UNITED STATES PATENT AND TRADEMARK OFFICE

APPLICATION NO.	FILING DATE	FIRST NAMED INVENTOR	ATTORNEY DOCKET NO.	CONFIRMATION NO.
10/784,302	02/24/2004	Seiichi Yamamoto	103213-00071	2270

Office Action Summary

DETAILED ACTION

FIG. 4A

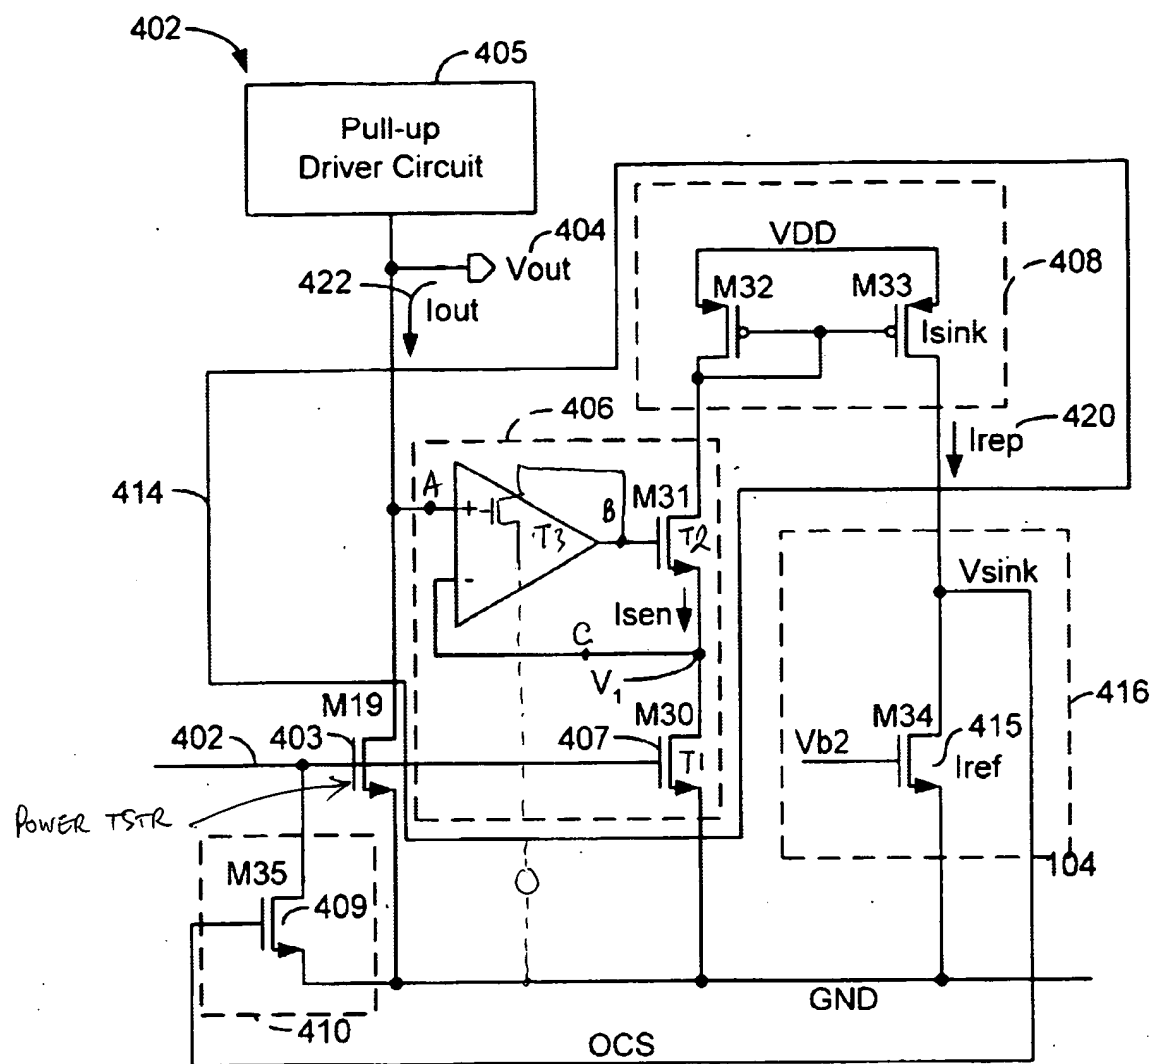
Regarding claim 3, figure 4A of Fotouhi shows a semiconductor integrated circuit comprising:

- a power transistor (M19) that feeds a current to a load;

- a first transistor (M30) of which a second electrode and a control electrode are connected respectively to a second electrode and a control electrode of the power transistor (M19);

- a second transistor (M31) of which one of a first electrode or a second electrode is connected to a first electrode of the first transistor (M30). Transistor (M19) draws a very large current (I_{out}) which is much larger (100 times) than the sense current (I_{sen}) drawn by transistor (M31) (col. 7 lines 1-12). Aota does not show that transistor (M19) is a power transistor. However, it is well known that a circuit having a power transistor can drive a large load. Therefore, it would have been obvious for one having skill in the art to replace transistor (M19) of Fotouhi with a power transistor so that the circuit of figure 4A can drive a heavy load coupled to the output (404).

Figure 4A of Fotouhi includes all the limitations of claim 3, except for the limitation that there is a third transistor coupled to the power transistor (M19) and to the second transistor (M31). It is well known in the art that an op-amp shown in figure 4A basically comprises two input transistors. Figure 4A of Fotouhi does not show the details of the op-amp comprising a third transistor having a gate connected to the first electrode of the power transistor (19) and a second electrode connected to a control electrode of the second transistor (M31). Figures 3 and 4 of Aota shows an op-amp B (M4-M7, M8) comprising a third transistor (M4) having a gate connected receive a first input signal, a second electrode connected to a control electrode of the second transistor (M8) that is equivalent to the second transistor (M31) of Fotouhi. The op-amp of Aota generates an output voltage (T_{vref}) that is independent of the temperature coefficient (col. 5, lines 6-14). Therefore, it would have been obvious to one having ordinary skill in the art the replace the op-amp (406) of Fotouhi with the op-amp B of Aota for generating an output voltage that is independent of the temperature coefficient. Note that the combination of Fotouhi and Aota comprises a semiconductor integrated circuit that comprise

a third transistor having a gate connected to the first electrode of the power transistor (M19) and a second electrode connected to a control electrode of the second transistor (M31). See attached drawings.

Regarding claims 4 and 7, the combination of Fotouhi and Aota shows that the first electrode (1) of the third transistor (M4) is connected to the second electrode (2) of the power transistor (M19) and the first transistor (M30). Figure 4 of Aota shows that a direct current voltage (Vcc) is applied to the second electrode of the third transistor (M4) through resistor (load resistor M6).

Regarding claim 5, the combination of Fotouhi and Aota shows that the second transistor (PMOS, M8) and third transistors (NMOS, M4) are transistors of opposite polarities and the second and third transistors are considered to be identical, otherwise stated, and to have the same gate-source voltages.

The second transistor (M8) and the first transistor (M30) are all NMOS transistors.
